S. No.	Cl. No.	CLAUSE CONTENT	COMMENT	REVISION
1	4.1.2.	Broken Slope	Change nomenclature	Broken back slope
2	4.1.2.	Water front reinforced soil wall.		Please include submerged wall
3	Figure 4.1 & Figure 4.5	Typical Cross Section of Reinforced Soil Walls	Filter media should be up to GL/SRL, embedment depth missing, $\Delta L$ & $\Delta H$ , Alternate fill.	Reassess the figure
4	4.2.1.1.	The maximum effective design friction angle shall be limited to 34°.	Maximum effective friction angle need not be limited. <b>FHWA</b> specifies 40°. Include <b>SP:102</b> ref of 38° degree - <b>CL 3.2</b> last paragraph.	
5	4.2.1.1.	Additionally, it is recommended that the maximum particle size of the reinforced fill shall be limited to 19 mm	Particle size passing 75mm and shall be w.r.t RFID. Refer <b>FHWA-24 CL 3.5.2.b</b> - RFID less than equal to 1.7

Comments and Points for  
Newly Drafted BIS RE Wall Code

Subject: Comments on Draft BIS code on Geosynthetic Reinforced Soil Structures — Code of Practice – Doc. No. TXD 30 (20465) September 2022

**Fig. 3.1 Schematic showing different fills in a Reinforced Soil Structure (Not to scale)**

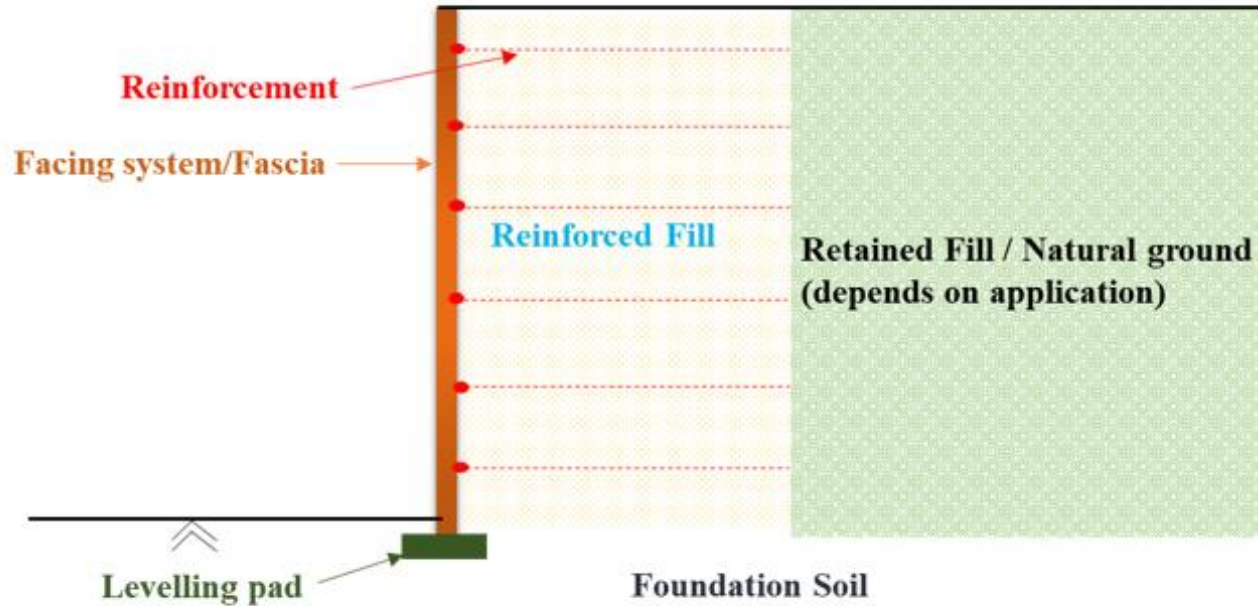
If any additional space required in Reinforced zone after geogrid, please mention in figure

Figure 0.1 Typical Cross Section of Reinforced Soil Walls

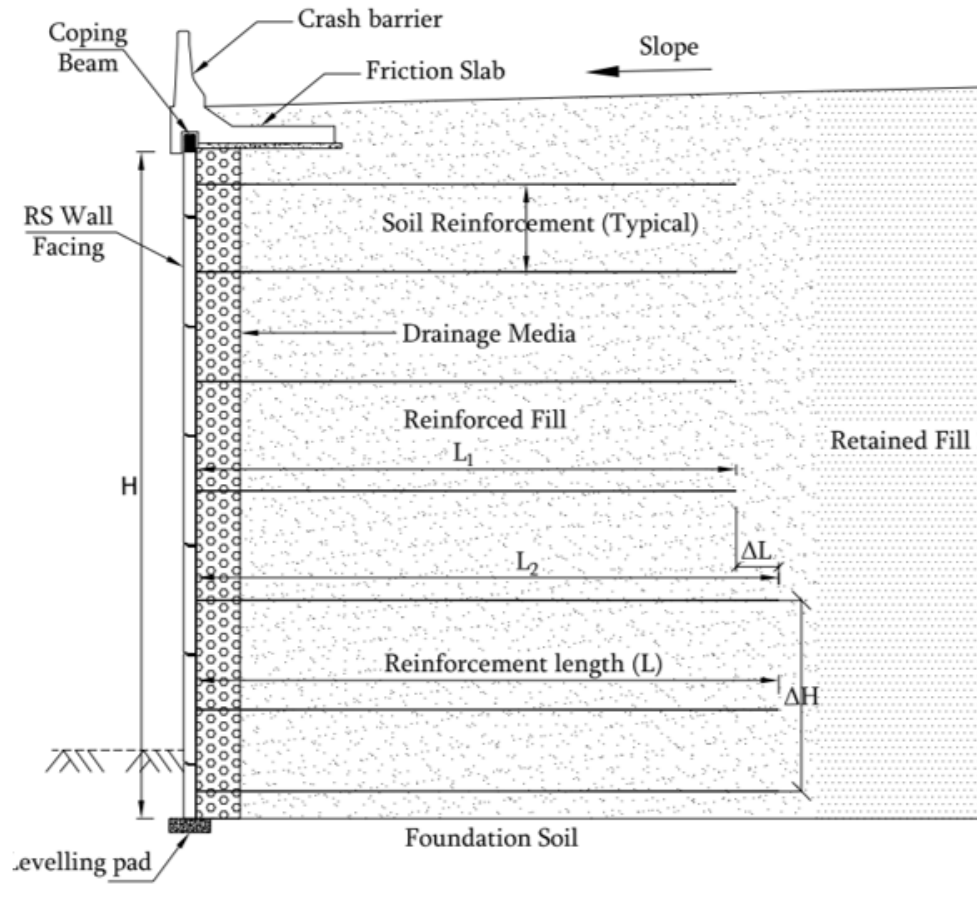
**AR** Anand Raghuwanshi    
Drainage media depth upto the pad level or SRL/OGL, please confirm.

Figure 0.5 Geometric Reinforcement Distribution Criteria of RS wall

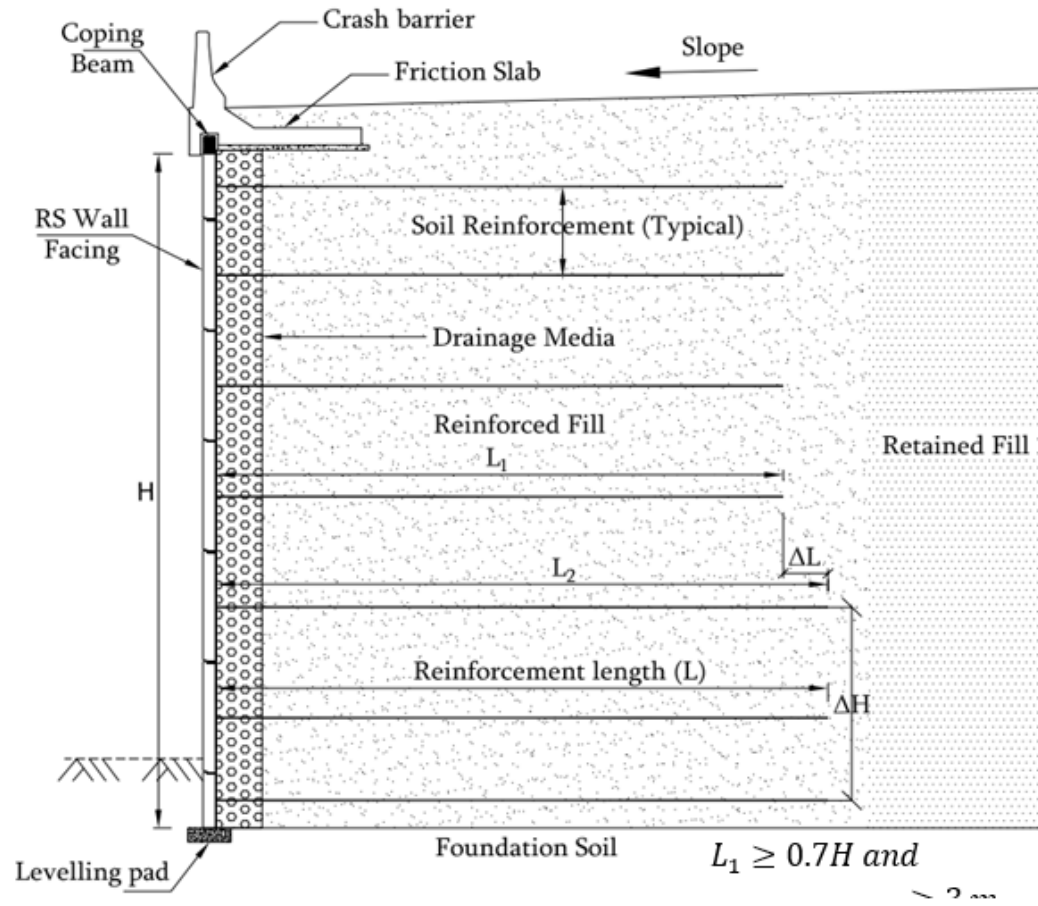
AR Anand Raghuvanshi Why the filter media required upto the pad level?

Figure 0.30 Dimensioning of RS wall with uneven reinforcement lengths

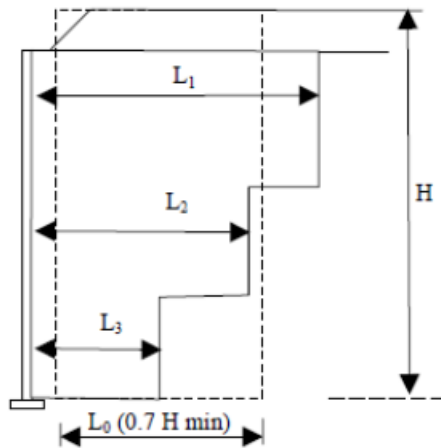
Detail design mechanism to be add in code

Figure 0.31 Overlap is  $0.3H_2$  and more, no Earth Pressure from backfill.  $H_1$  is taller wall and  $H_2$  is shorter wall.

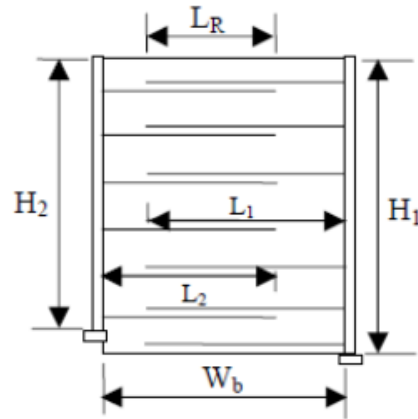
1. Also mention about the slenderness ratio of wall.
2. Minimum length of r/f..?

Figure 0.33 Typical Cross Section of Water front RS wall

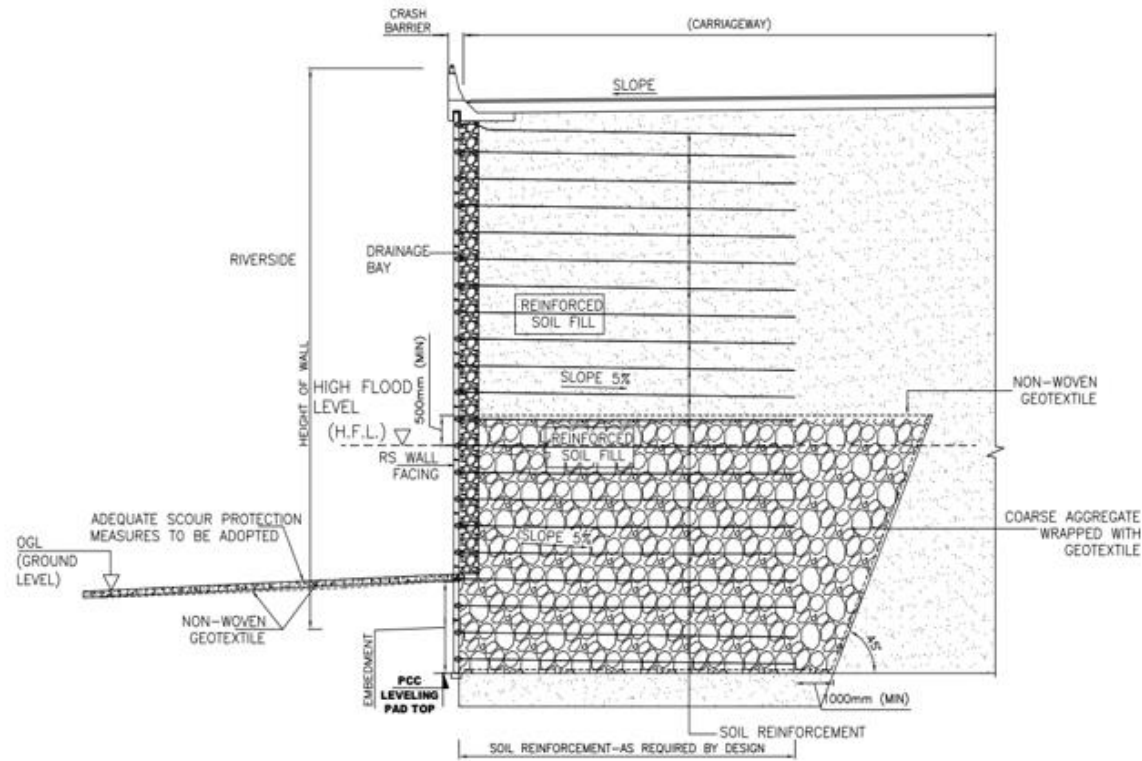
Filling of coarse aggregate, violating the clause of phi value and gradation of fill. Please confirm.

Figure 22 Drainage features for consideration when water is present in reinforced soil structure (Typical precast concrete block fascia)

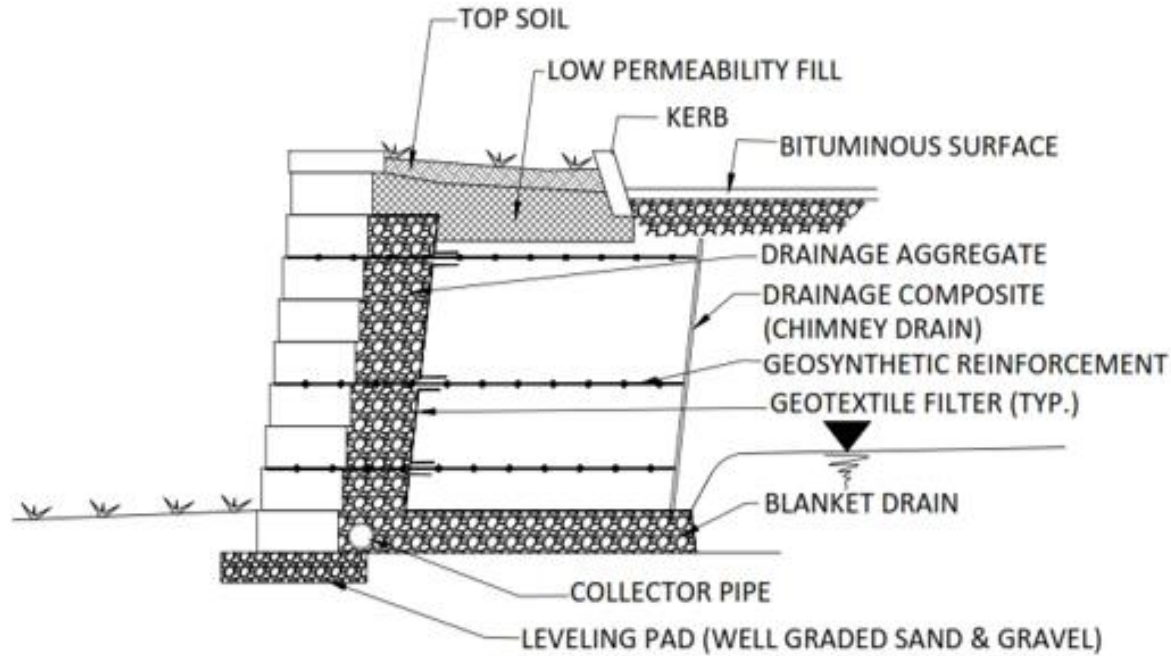
How to plan outlet of collector pipe

Figure 10-1. Example traffic barrier for Reinforced Soil walls:  
(a) barrier on top of panel facing, (b) barrier on top of modular block units.

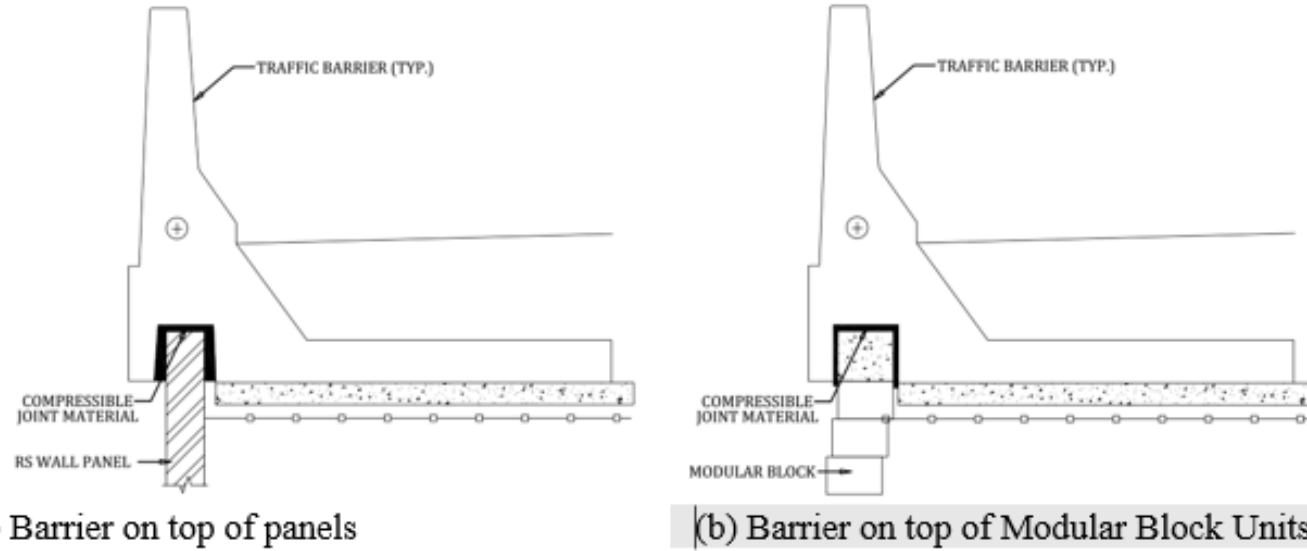
Unable to fix top grid bcus of CB and GSB layer

## 10.2.9 Successive face element erection and batter

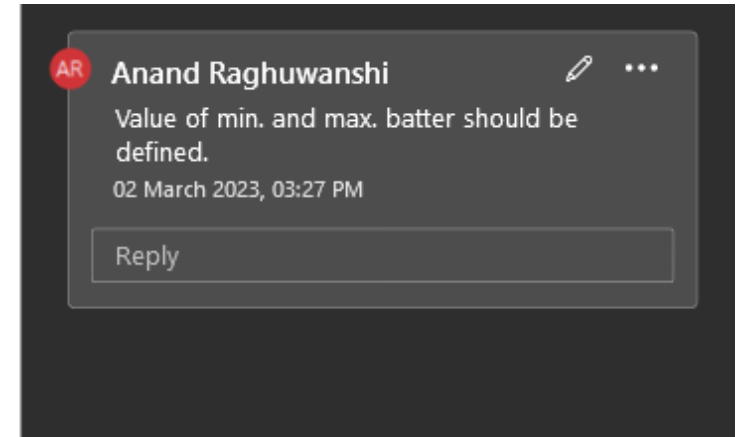
Value of min. and max. batter should be defined.
